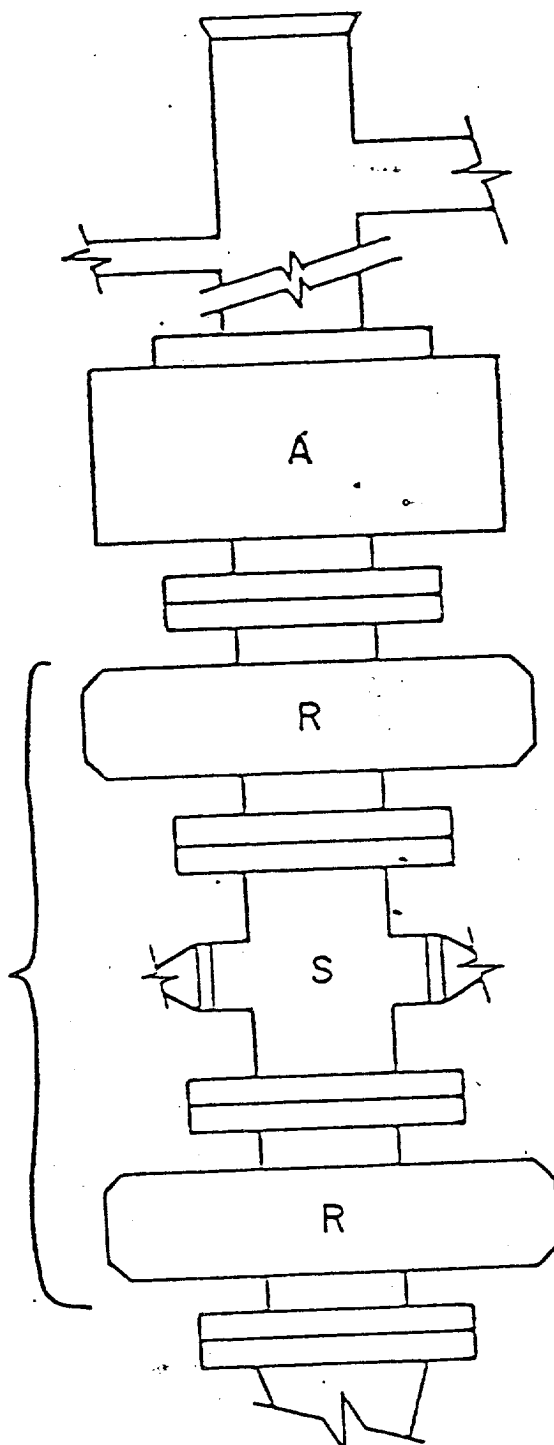
This may be a double
with a side outlet

NOTE: IT IS RECOMMENDED THAT THE CHOKE LINE BE ATTACHED
ABOVE THE BOTTOM PREVENTER
